Access Compliance Report

Public Rights-of-Way

(Curb Ramps)

Intersection ID: 31313	Main Street: DEERTON_RD	Cross Street: EBEN_DR	Location:	W
ADA ID: 3F7AF6D97CD7	Ramp Type: PerpDiag	Initial Pass/Fail: Fail	Overall Compliance: No	Severity Score: 10
Codes/Mitigation Info/Possible Solution		Field Measurements/Component Compliance

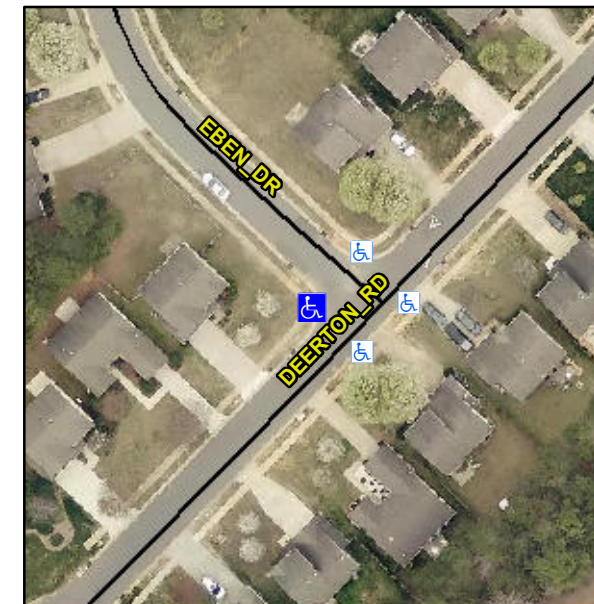
R304.5.1, R304.5.3

Compliance	Description	Data	Compliance	Description	Data
N/A	Ramp Length (in)	50.0	Yes	Ramp Slope (%)	7.1
No	Ramp Width (in)	37.0	No	Ramp XSlope (%)	3.0
N/A	Flare Type LT	N/A	N/A	Flare Type RT	N/A
N/A	Flare Slope LT (%)	N/A	N/A	Flare Slope RT (%)	N/A
N/A	Flare Traversable LT?	N/A	N/A	Flare Traversable RT?	N/A
N/A	Landing Length (in)	N/A	N/A	DWS Provided?	N/A
N/A	Landing Width (in)	N/A	N/A	DWS Contrast?	N/A
N/A	Landing Slope (%)	N/A	N/A	DWS Length (in)	N/A
N/A	Landing X Slope (%)	N/A	N/A	DWS Full Width?	N/A
N/A	Landing Curb? (Y/N)	N/A	N/A	DWS Offset (in)	N/A
N/A	Shared Landing?	N/A			
N/A	Gutter Ponding?	N/A	N/A	Gutter Slope (%)	N/A
N/A	Gutter Lip Ht (in)	N/A	N/A	Gutter X Slope (%)	N/A
N/A	Painted X Walk1?	No	N/A	Painted X Walk2?	No
	X Walk 1 Direction	To SE		X Walk 2 Direction	To NE
N/A	X Walk 1 Width (in)	N/A	N/A	X Walk 2 Width (in)	N/A
	X Walk 1 Slope (%)	0.9		X Walk 2 Slope (%)	1.4
	X Walk 1 X Slope (%)	1.2		X Walk 2 X Slope (%)	2.1

Remove & Replace Curb Ramp With Two New Directional Ramps or Equivalent.
